## Lewis River Fish Passage Subcommittee Meeting

**FINAL Meeting Notes  
Lewis River License Implementation  
ACC Fish Passage Subcommittee Meeting  
September 14, 2023  
2:30 PM – 4:30 PM  
MS Teams Meeting**

# Fish Passage Design Update

# Sorting Building Layout – “No Touch”

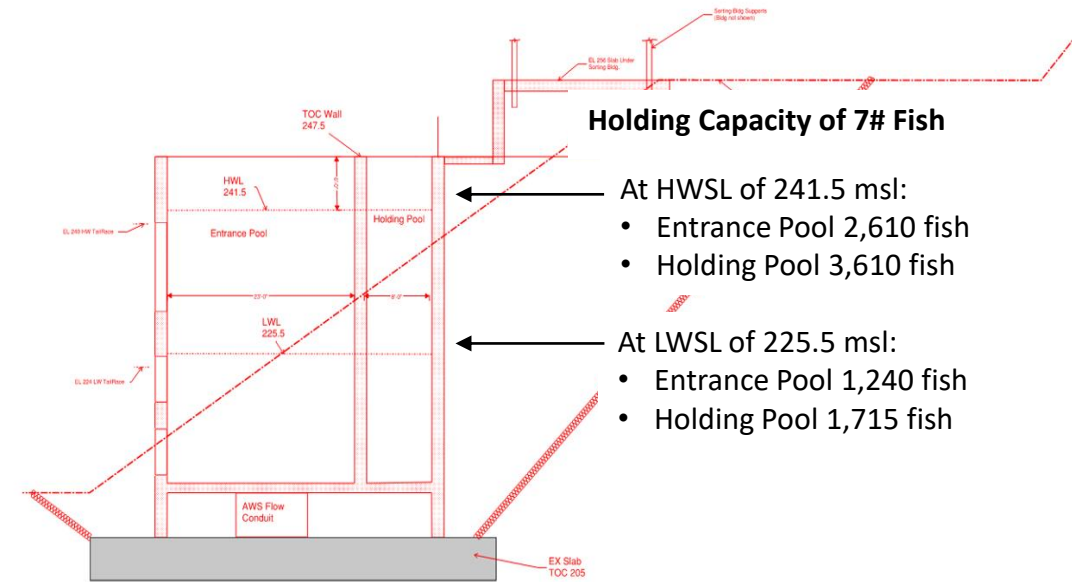
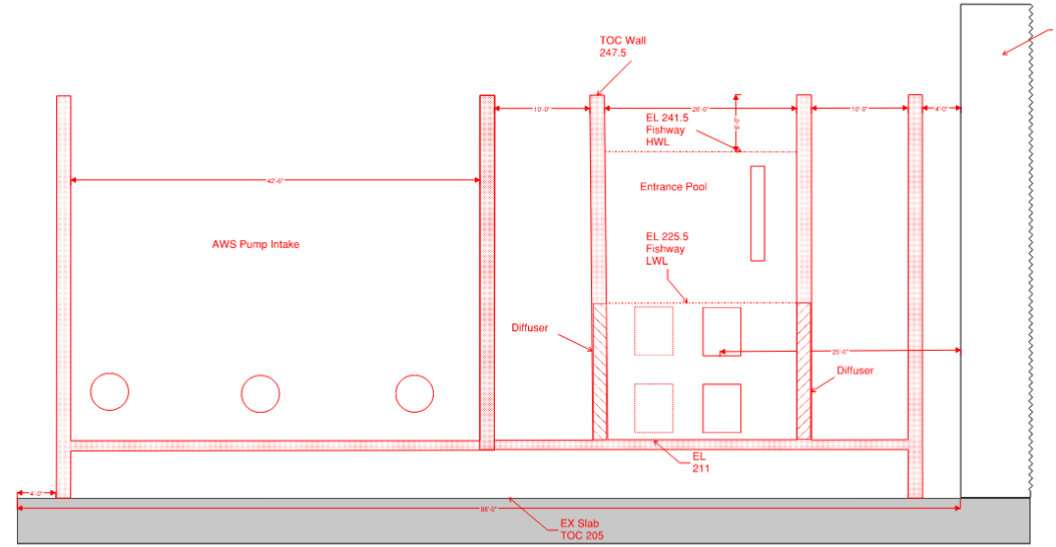
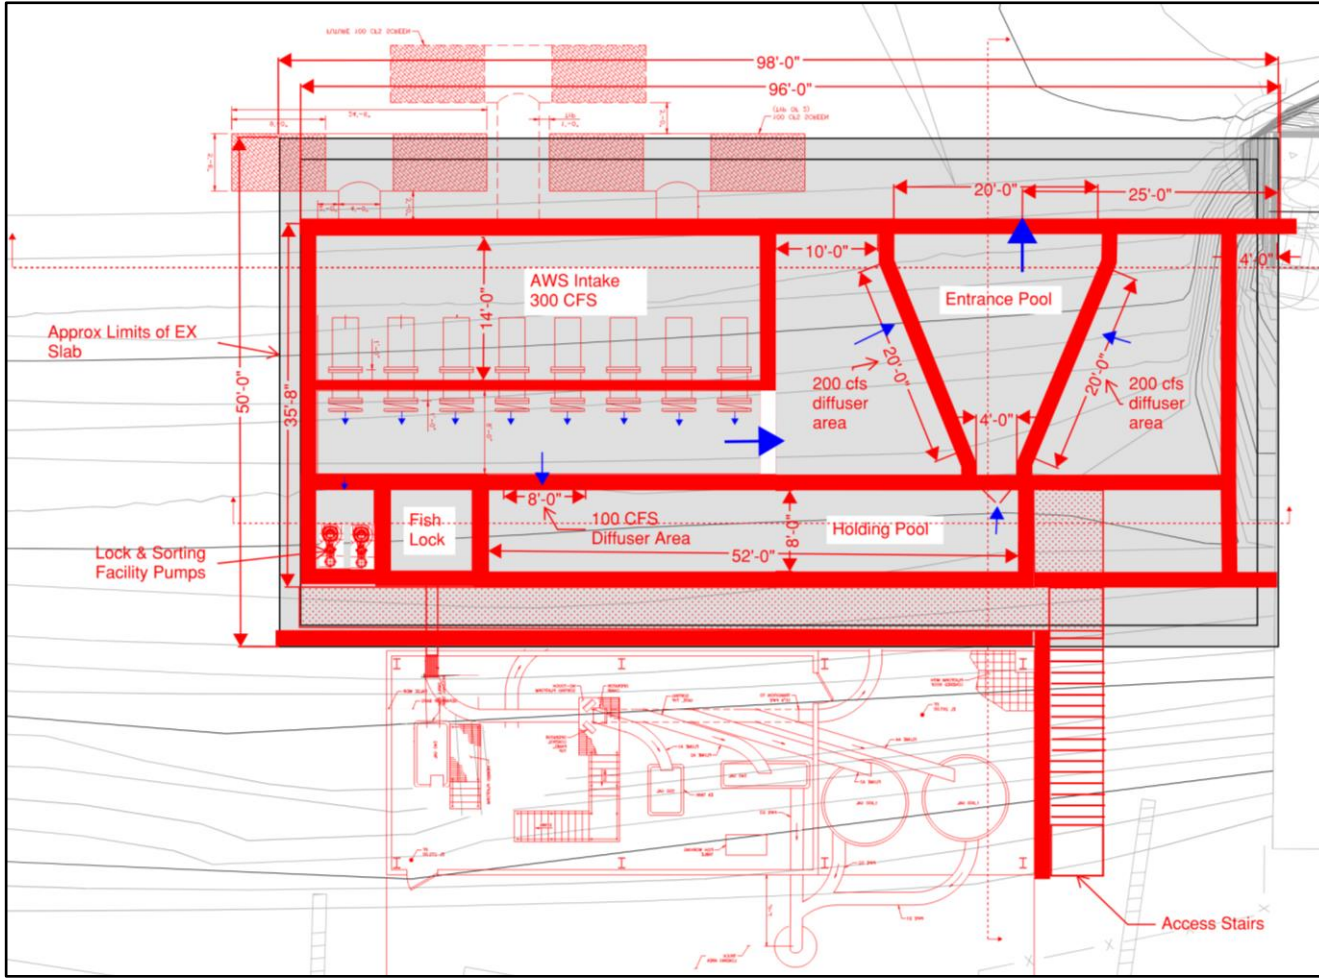
*No touch facility:* Karchesky indicated that based on the 30% Design comments, the design team moved from a manual sorting facility concept to a "no-touch" design concept. Karchesky presented the new configuration. There is a small fish separator bar at the top of the fish lock to separate any small size fish initially which we learned about from the Baker Facility. The larger fish would continue to slide down the sorting table to be viewed by an observer before being sorted into holding tanks. Miller asked if there is still room for the ability to put more tanks out if needed to which Karchesky replied, yes, there is. There will be more information in the 60% design. Higa added the design team is building in room for expansion, as needed.
